Subject: Gen2 Electronic Clutch Actuator (ECA) Interference

Document Number: TAIB0862

Notice No. **R2016-01 (Revised)**

Service Parts CHANGE Notice

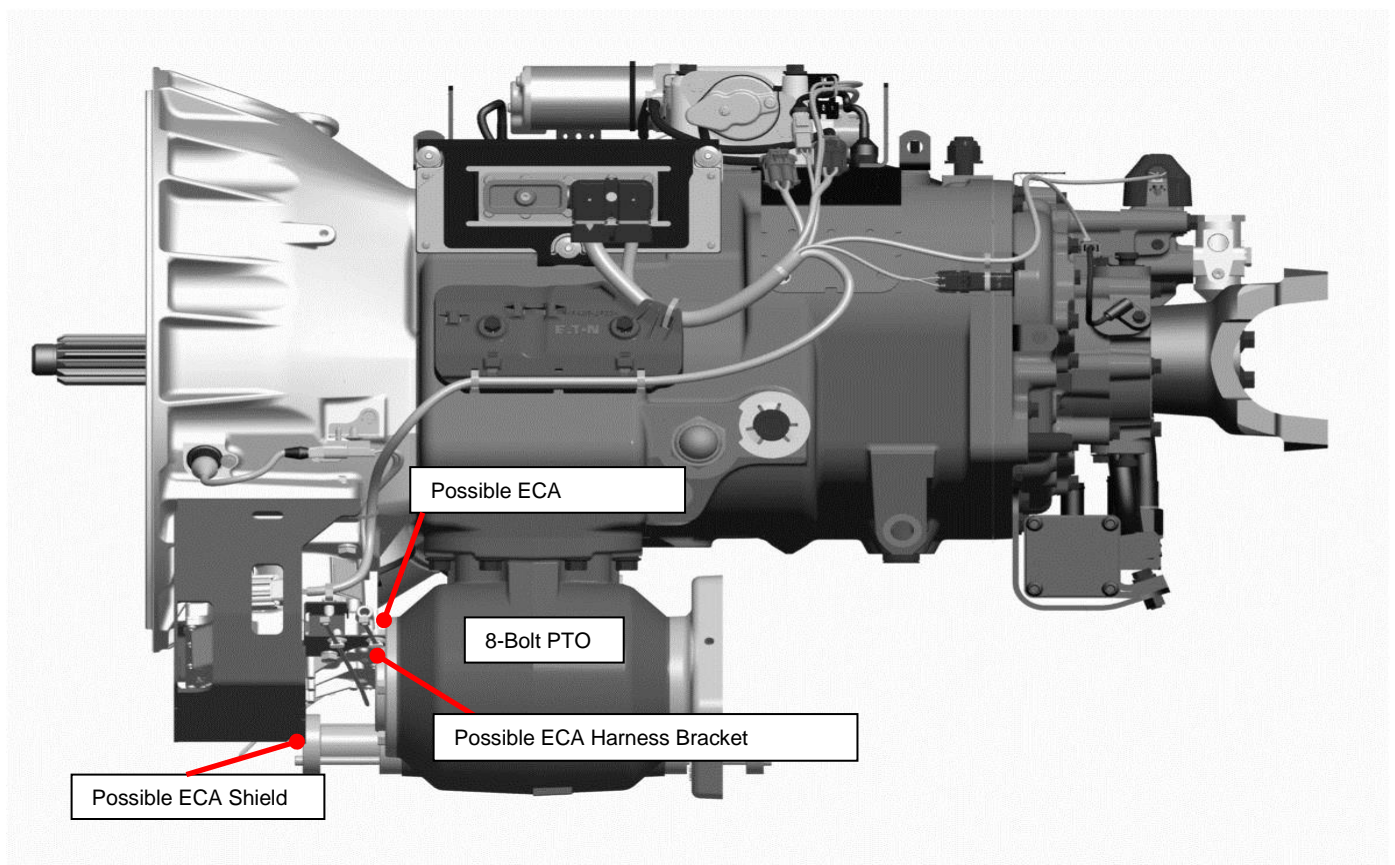
When replacing a Gen1 ECA with a Gen2 ECA, the Gen2 ECA can interfere with specific 8-bolt countershaft PTO models. Interference varies, and depending on the PTO model the interference could be with the ECA, ECA Shield or the ECA Harness Bracket.

Specific Known PTO Model Installations with Gen2 ECA Interferences:

PTO Mfg	PTO Model
Chelsea	238X-3XBD
Chelsea	823X-A3XS
Chelsea	885X-A3XS
Chelsea	885X-A5XS

PTO Mfg	PTO Model
Muncie	828S-Q1XX
Muncie	828S-D1XX

Field Strategy: Prior to ordering the PTO for a new installation with a Gen2 ECA, contact Muncie or Chelsea applications to confirm available / suitable PTO model.

When replacing a Gen1 ECA in combination with the specific PTO models listed contact Eaton at (800) 826-4357 to order a K-4310 (Gen1 ECA) to replace the failed Gen1 ECA.
